HISTORIC AND DESIGN REVIEW COMMISSION

August 05, 2015

HDRC CASE NO: 2015-291
COMMON NAME: 100 E Crockett / Crockett Street Bridge
ZONING: UZROW
CITY COUNCIL DIST.: 1
DISTRICT: Alamo Plaza Historic District
LANDMARK: Crockett Street Bridge
APPLICANT: Brian Kuehl
OWNER: City of San Antonio
TYPE OF WORK: Crockett Street Bridge Improvements
REQUEST:

Crockett Street Bridge Rehabilitation Description & Exhibits for HDRC

CROCKETT STREET BRIDGE UNDER BRIDGE TREATMENT CONCEPT

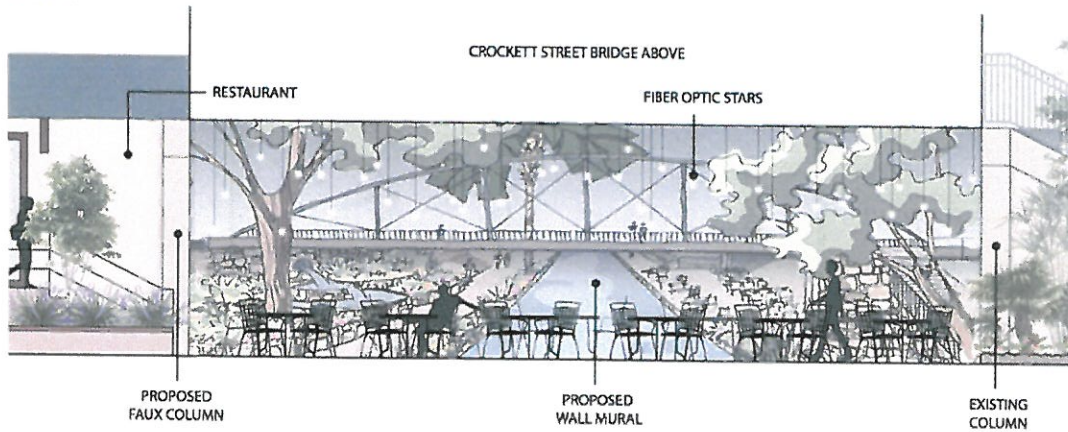
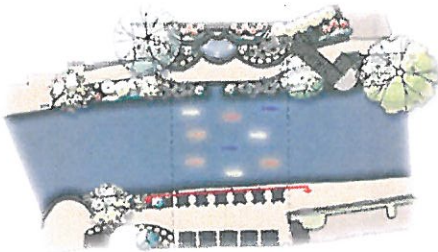
- d. Per the UDC Section 35-673(f) regarding plant materials, projects along the Riverwalk should incorporate existing vegetation and use indigenous and noninvasive species. The applicant has proposed to replant the existing planters beneath the bridge while preserving a row of existing vegetation. The applicant is responsible for complying with the UDC regarding the appropriateness of specific plant materials.

- e. The applicant has proposed to introduce various lighting features both beneath the Crockett Street Bridge and in the surrounding area at the Riverwalk Level. The proposed lighting includes lighting in the existing planters, lighting in the existing fountain, casting a light pattern onto the river below, simple down lighting on the wall, fiber optic stars over river level seating, replacing bridge lighting and replacing pedestrian oriented lighting as needed at the Riverwalk level. Generally, the applicant's request is consistent with the UDC Section 35-673(j) regarding lighting, however, both the proposed painted mural and river projection shall be reviewed by Public Art San Antonio (PASA) per UDC Division 5.

- f. According to the UDC Section 35-643(a), every reasonable effort shall be made to adapt the property in a manner which requires minimal alteration of the building, structure, object, or site and its environment. To ensure that no irreparable damage is done, staff recommends that the applicant provide information regarding lighting fixtures and their mounting to any historic element. The applicant should provide this information prior to returning to the HDRC.

- i. That the applicant provide additional information and specifications on the proposed fiber optic star lighting and additional information on the proposed painted mural and river projection as well as coordination with PASA regarding any proposed publicly displayed art.
- ii. That the applicant provide additional information regarding the proposed lighting fixtures and how they will be mounted to any historic element.
